UNITED STATES PATENT AND TRADEMARK OFFICE

APPLICATION NO.	FILING DATE	FIRST NAMED INVENTOR	ATTORNEY DOCKET NO.	CONFIRMATION NO.
10/733,307	12/12/2003	Tsutomu Muraoka	SN-US025011A	7330

Office Action Summary

1. The Amendment filed on February 10, 2005 has been entered.
2. Applicant's election without traverse of the species of Figs. 27 and 28 in the reply filed on November 17, 2004 is acknowledged.
3. No claim is withdrawn from further consideration pursuant to 37 CFR 1.142(b) as being drawn to a nonelected species, there being no allowable generic or linking claim. Election was made **without** traverse in the reply filed on November 17, 2004.
4. The text of those sections of Title 35, U.S. Code not included in this action can be found in a prior Office action.
5. Claims 29-33 and 35-37 are rejected under 35 U.S.C. 102(b) as being anticipated by Date (Japanese Utility Model No. 5-319350).

【図8】

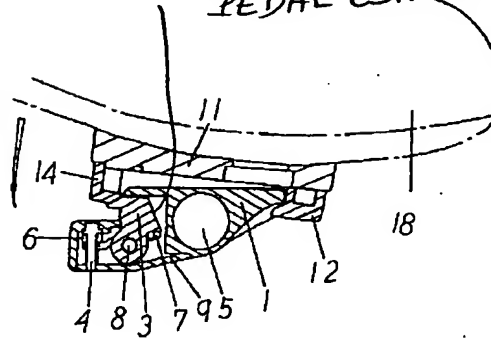
Regarding claim 30, said cleat engagement mechanism 3, 2 includes a front clamping member 2 (Fig. 7) coupled to said front end of said pedal body 1, q and a rear clamping member 3 (Figs. 8 and 9) movably coupled to said rear end of said pedal body 1, q.

Regarding claim 32, said front clamping member 2 includes a rearwardly facing front pedal control surface (Att.), said rear clamping member 3 includes a forwardly facing rear pedal control surface (Att.).

FORWARDLY FACING REAR
PEDAL CONTROL SURFACE

【図10】

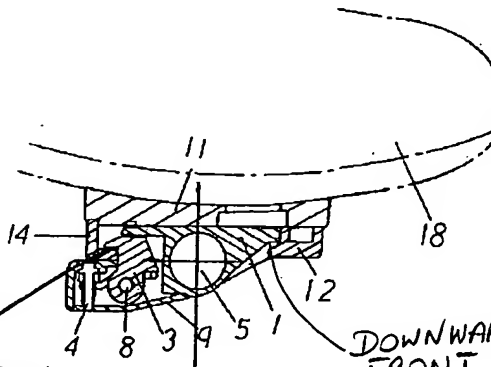
Regarding claim 31, said front clamping member 2 includes a downwardly facing front cleat engagement surface (Att.) disposed in a first plane (Att.), and said rear clamping member 3 includes a downwardly facing rear cleat engagement surface (Att.) disposed in a second plane (Att.) that is offset from said first plane (Att.) of said front cleat engagement surface 2 as best seen in Figs. 2 and 10.

Regarding claim 33, said front and rear cleat engagement surfaces (Att.) are *substantially* parallel as seen in, e.g., Figs. 2 and 10.

Date's first plane (Fig. 10 of Att.) of the front cleat engagement surface 2 is farther to the center rotation axis (Att.) than the second plane (Att.) of the rear cleat engagement surface (Att.) as measured in a direction perpendicular to the first and second planes (Att.).

DOWNWARDLY FACING REAR
CLEAT ENGAGEMENT
SURFACE/SECOND PLANE

DOWNWARDLY FACING
FRONT CLEAT ENGAGEMENT
SURFACE/FIRST PLANE
